Preliminary Consultation
MONTGOMERY COUNTY HISTORIC PRESERVATION COMMISSION
STAFF REPORT

Address:	20 West Lenox Street, Chevy Chase	Meeting Date:	4/13/11
Resource:	Contributing Resource Chevy Chase Village Historic District	Report Date:	4/6/11
Applicant:	Daniel and Kristen Coughlan (Matthew Fiehn, Architect)	Public Notice:	3/30/11
Review:	Preliminary Consultation	Tax Credit:	N/A
Case Number:	N/A		
PROPOSAL:	Construction of side and rear additions, alterations to house and driveway and tree removal		
Staff:	Josh Silver

Address:	20 West Lenox Street, Chevy Chase	Meeting Date:	2/23/11
Resource:	Contributing Resource Chevy Chase Village Historic District	Report Date:	2/16/11
Applicant:	Daniel and Kristen Coughlan (Matthew Fiehn, Architect)	Public Notice:	2/9/11
Review:	Preliminary Consultation	Tax Credit:	N/A
Case Number:	N/A	Staff:	Josh Silver

COUGHLAN RESIDENCE
 SITE PLAN
 BARNES VANZE ARCHITECTS
 03-24-11
 1/16" = 1'-0"

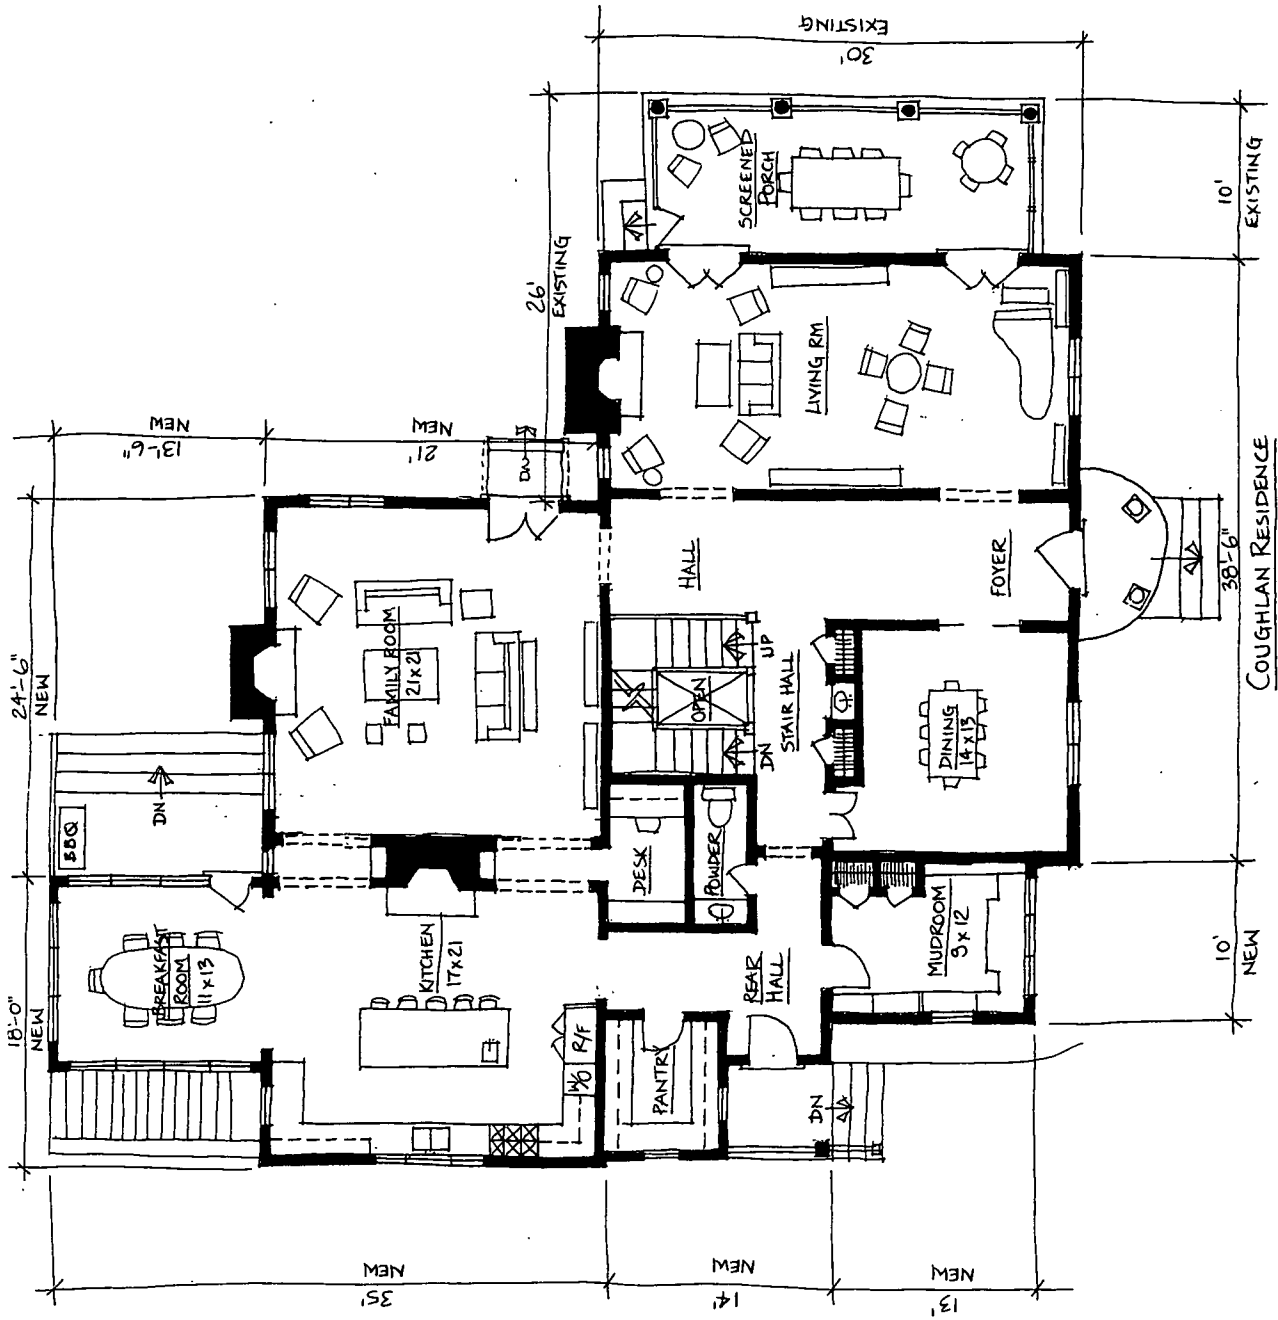
The proposed work also includes narrowing the existing side yard driveway that provides access to the garage to a maximum width of 5'6". A 18" planting bed between the proposed addition and driveway is proposed to provide a buffer between the driveway and proposed addition.

Staff supports the proposed removal of the Red Maple tree in the front yard to accommodate this addition pending approval of a waiver from Chevy Chase Village.

The recommended changes would also help preserve most of the existing side yard driveway, which is a typical characteristic of Village properties with rear yard accessory structures. The *Guidelines* state: "The goal of new construction within the historic district is to be sympathetic to the traditional street and building patterns in the district, while allowing for creative and new building designs." (Page 18) A narrower and shorter side addition would be more consistent with the building pattern along West Lenox Street, which includes examples of side yard driveway accesses to rear yard accessory structures.

Staff recommends that the applicants continue consultation with the Village arborist to ensure appropriate tree protection measures are taken prior to commencing work at the property. Specific attention should be given to the protection of the White Oak tree on the shared property line to the west.

FRONT ELEVATION

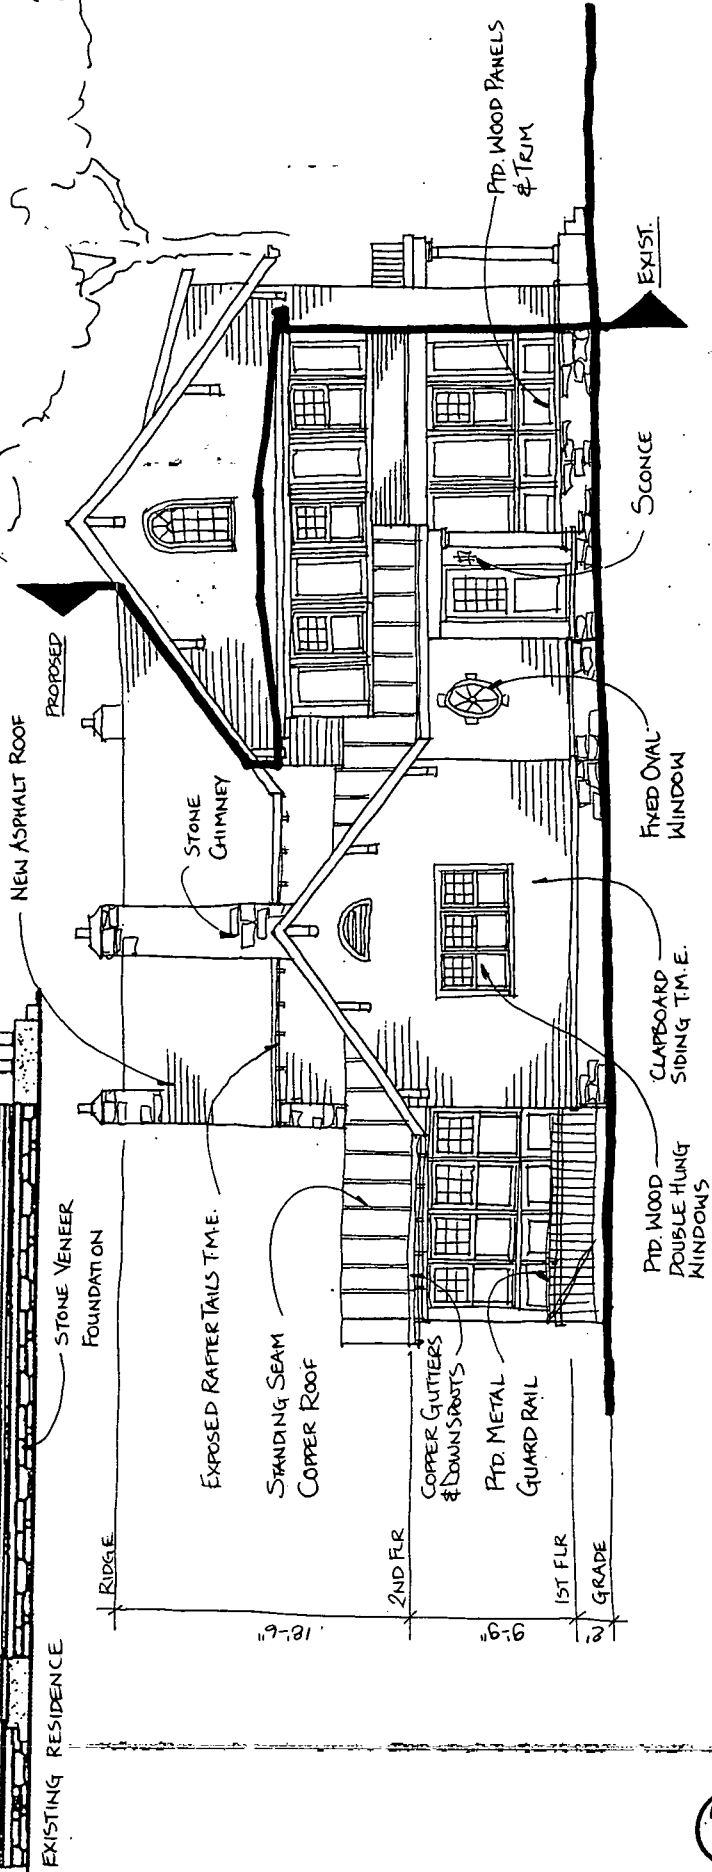
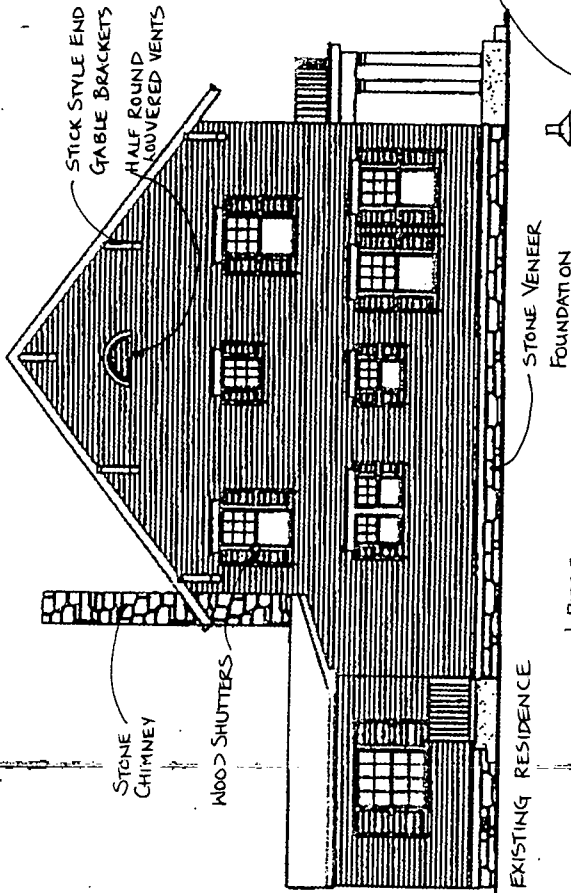
Staff supports the construction of the 2 story hipped roof side addition. The proposed scale and articulation of the side addition is complementary to the existing 2 story projection on the right (west) side elevation and in character with the style of the historic massing. Staff recommends that 6/1 double-hung windows be installed in locations where wooden panels are proposed in lieu of windows to create cohesion throughout the design of the addition.

Staff supports the installation of dormers on the historic massing. The installation of dormers is consistent with *Guidelines* and would not adversely affect the historic character of the structure.

DRIVEWAY ELEVATION

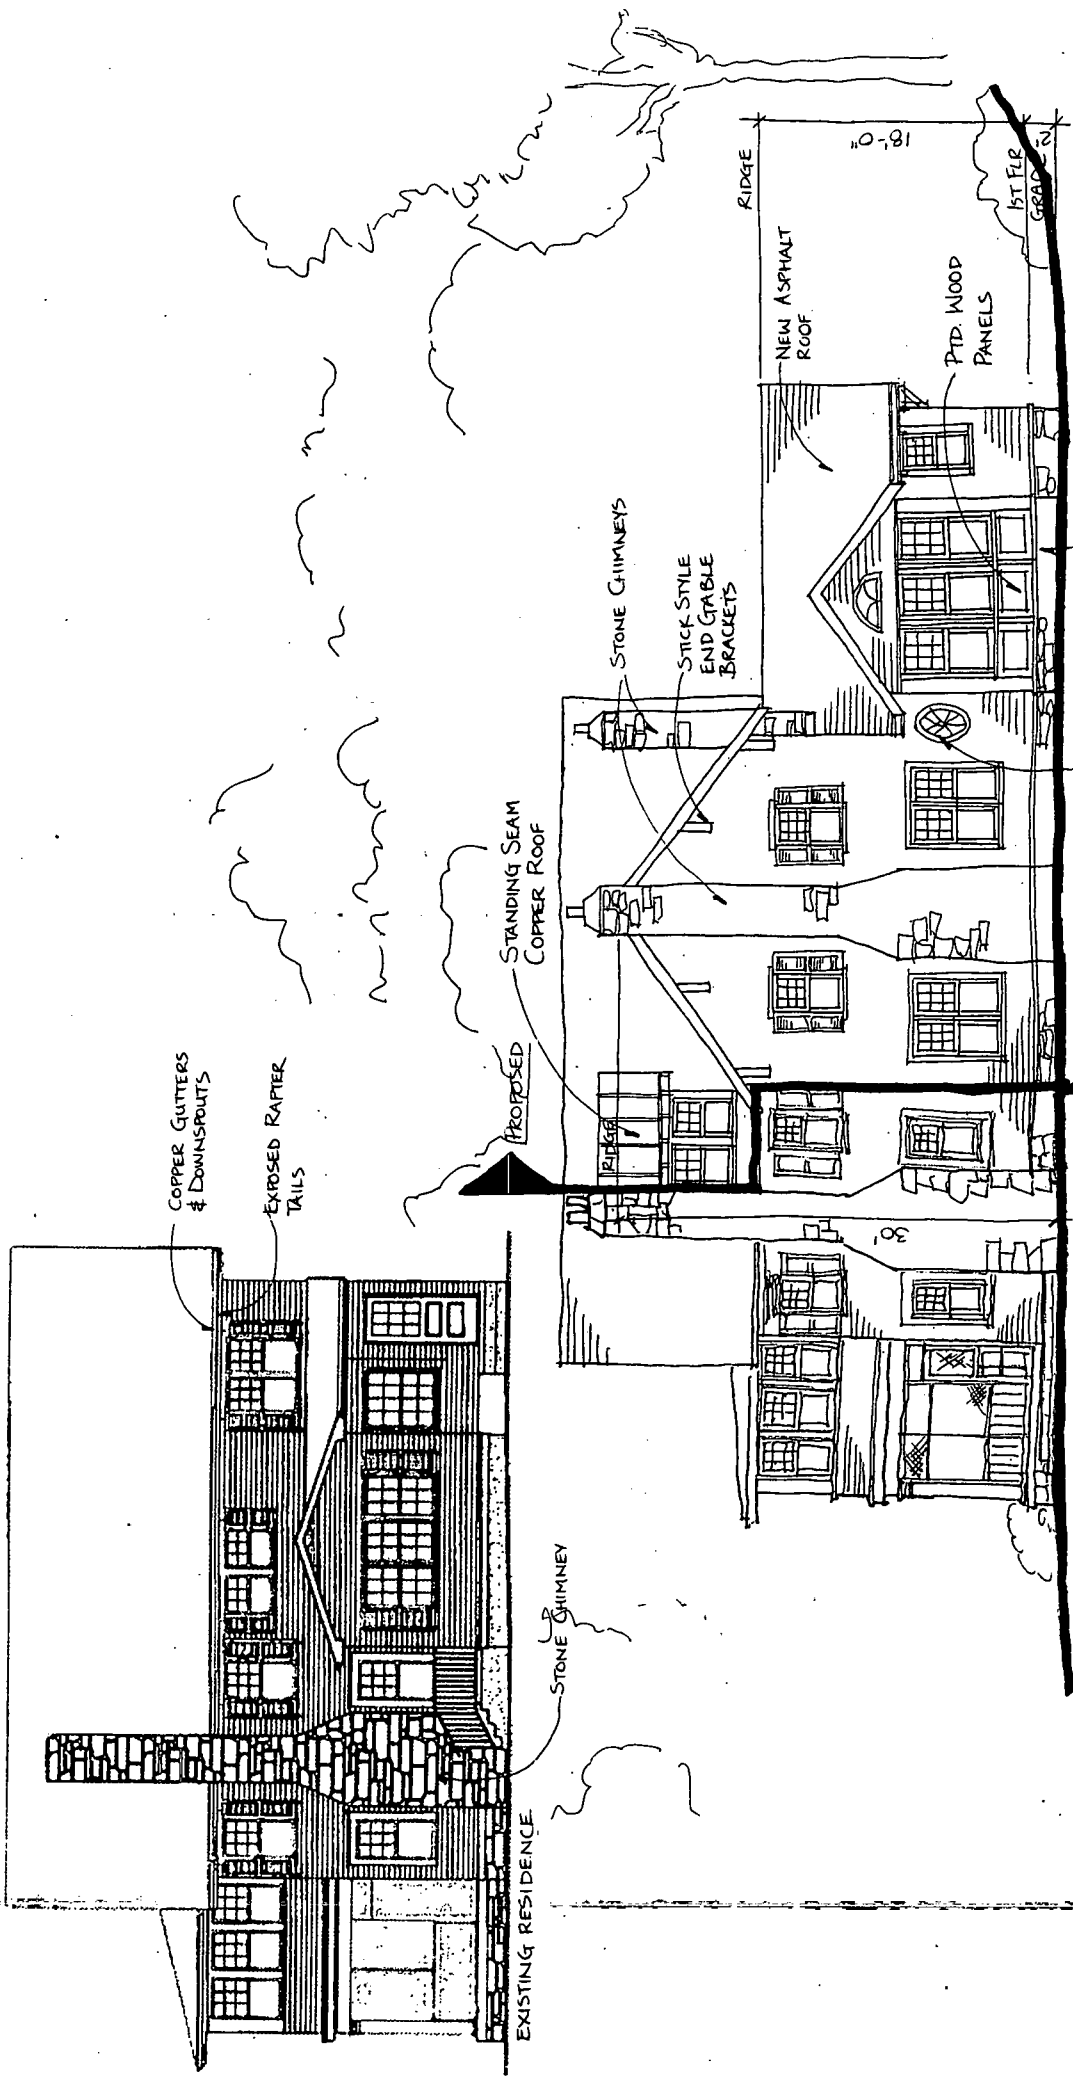
Staff supports the proposed construction of a 1 story gable and shed roof side addition on the left (east) side elevation. However, staff is concerned with the cumulative impact of these additions to historic massing and their impact on the streetscape of the historic district. Staff recommends reducing the depth of the proposed 1 story gable addition section so that it does not project beyond the eave line of the 1 story shed roof section. Staff also recommends reducing the length of the 1 story shed roof section that terminates as a gable in the rear yard.

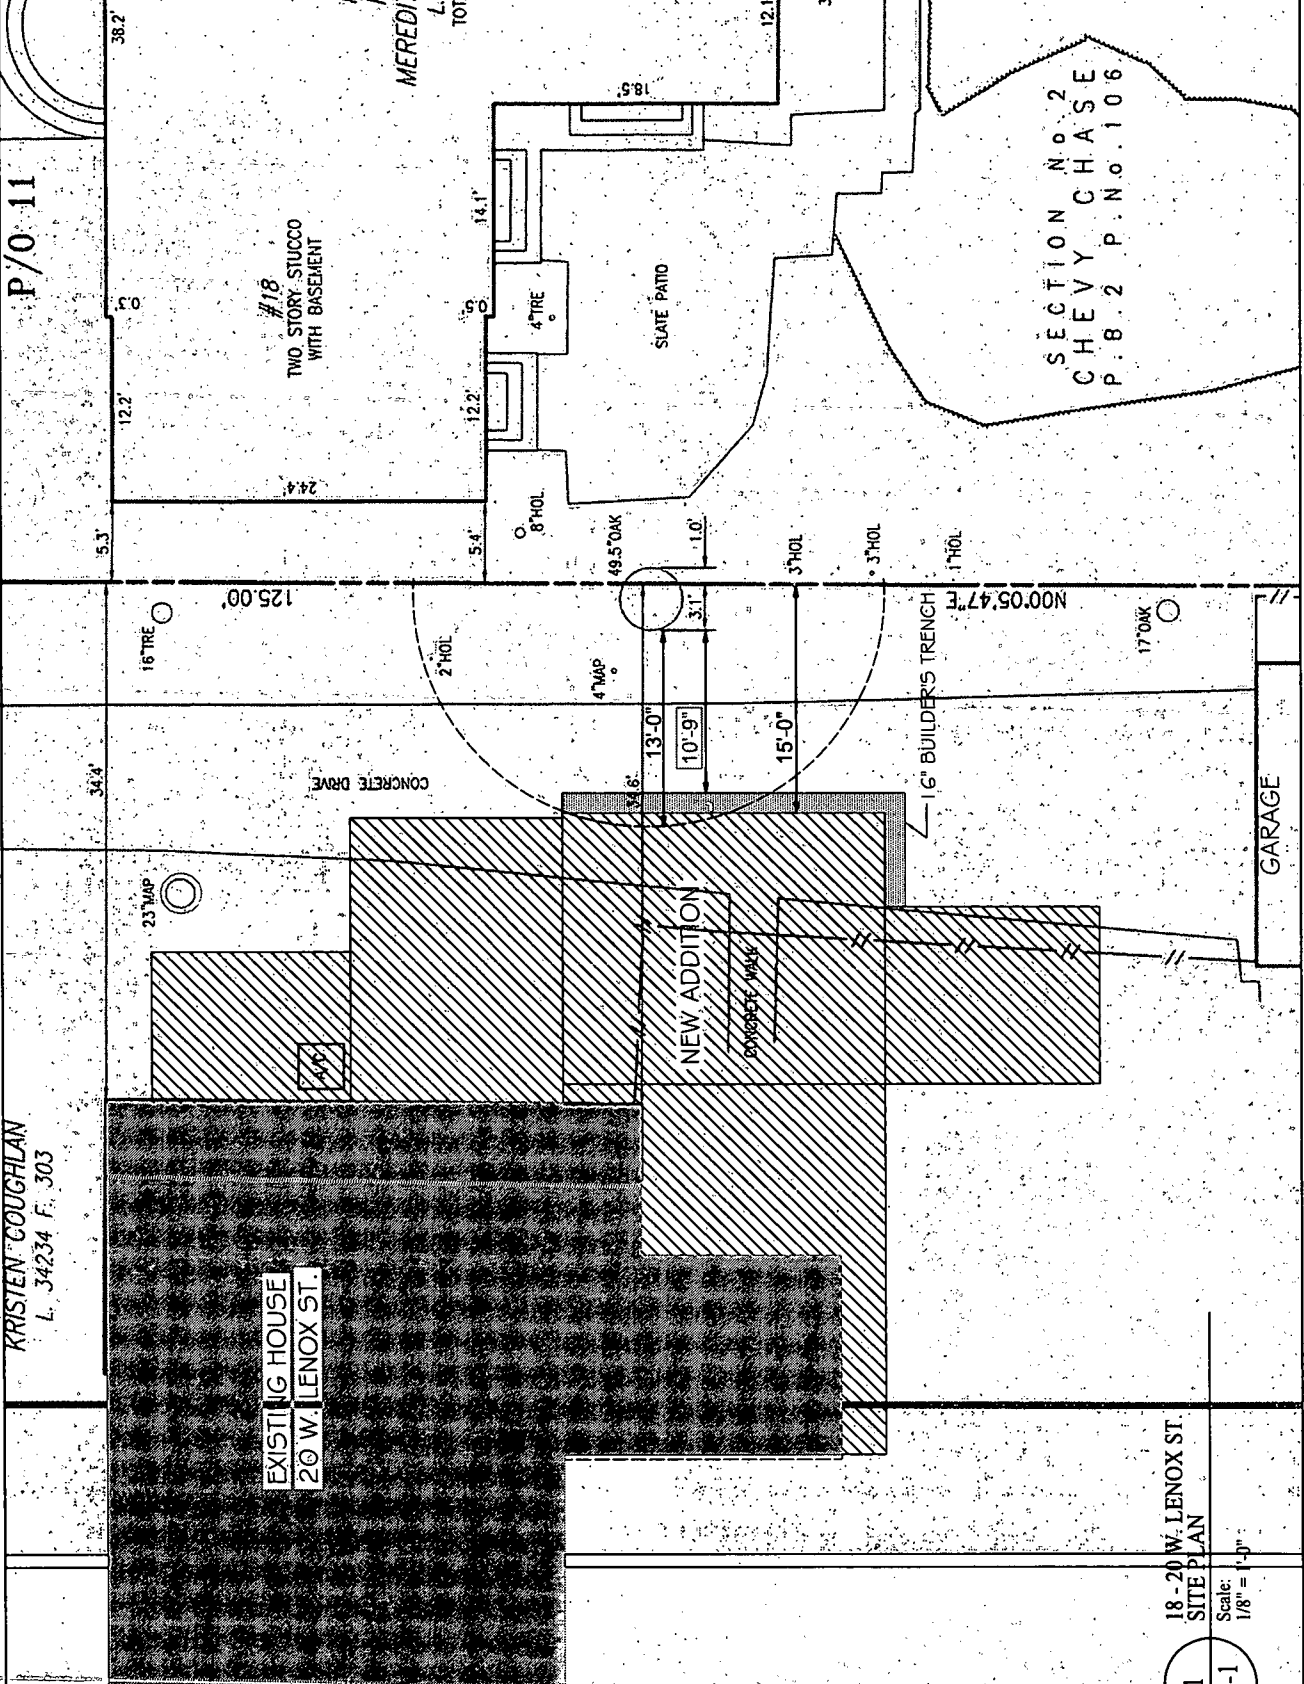
The Staff Report states that, “Special attention should be given to the protection of the White Oak tree on the shared property line to the west.”p. 5. Of course, the Guidelines state that “Tree removal should be subject to strict scrutiny and consistent with the Chevy Chase Village Urban Forest Ordinance.” p. 17. Not abiding by the tree protection plan is de facto tree removal.

I have attached, and am submitting for the record, a certified boundary survey that Charles P. Johnson & Associates prepared for me showing the exact location of a specimen White Oak, as well as an exhibit that Martin Rosenblum, my consulting architect, prepared showing the proposed addition on the boundary survey, and the encroachment of the proposed addition on the tree save area required by Chevy Chase Village. These documents were before the Board of Managers last evening when the Board found the encroachment.

I therefore request that in the Preliminary Consultation tomorrow night that the Commission counsel the Applicant to, at a minimum, move the proposed project out of the 13 ft. Tree Save area, and to provide another 16 inches, as shown on the attached MJRA survey, for the builder’s trench. That is a total of approximately 3.5 feet.

CLIENT: Meredith Wellington 18 West Lenox Street Chevy Chase, Maryland 20815	PRELIMINARY PLANING SITE PLANING
DESIGN: SWP	SHEET: 1 OF 1
DRAWN: DBJ	DATE: 04/05/2011
SCALE: 1" = 10'	FILE NO.: 41-080-C60

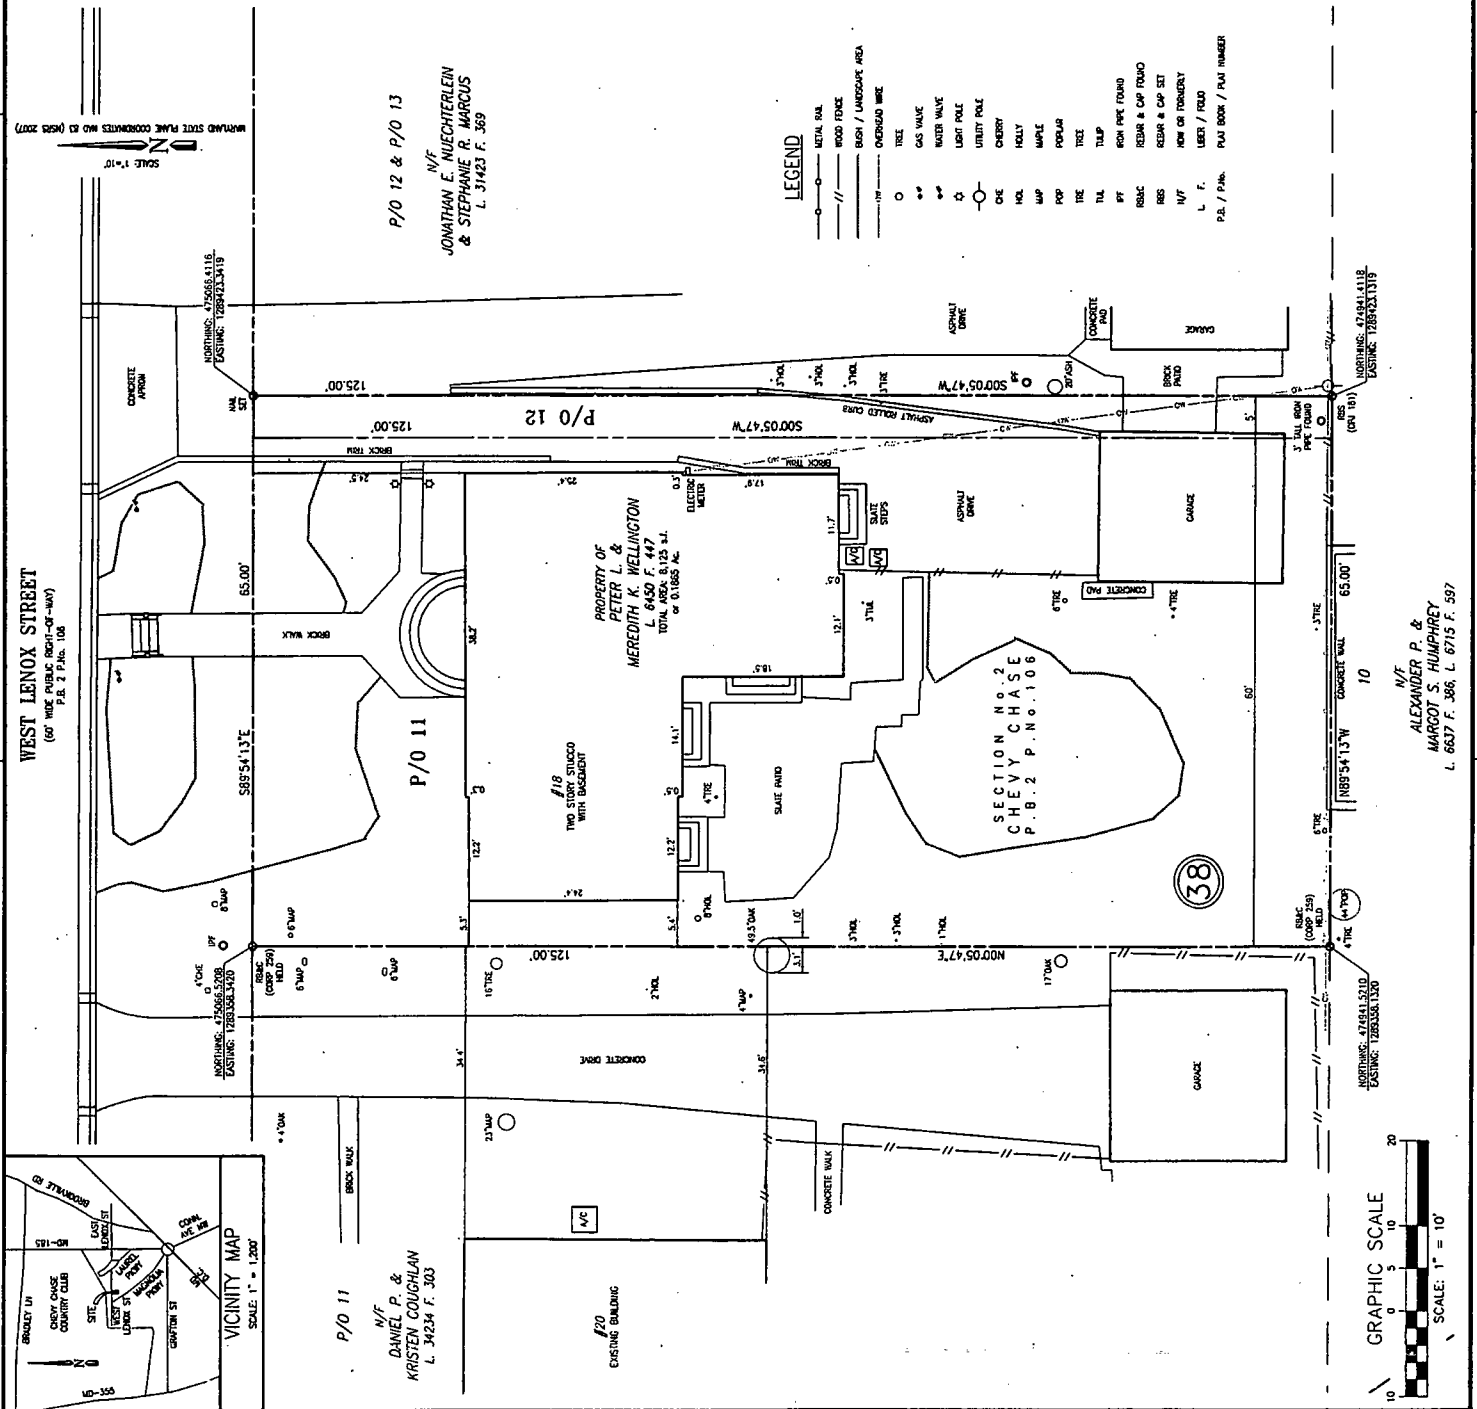
Also, regarding 20 West Lenox Street, the arborist has determined that the White Oak on the property line with 18 West Lenox Street will require a thirteen (13) foot radius of tree preservation (not from the center but around the trunk). Because this encroaches on the current plan as submitted by the resident, the Board required that a boundary survey be provided by the resident and that any proposed addition accommodate this radius prior to issuance of the permit.

The resident and architect stated that they can submit a plan which will comply with the tree preservation requirement. Per Village permitting process, HPC and Montgomery County permits must be issued prior to the Village review and tree preservation must be installed prior to issuance of the permit.
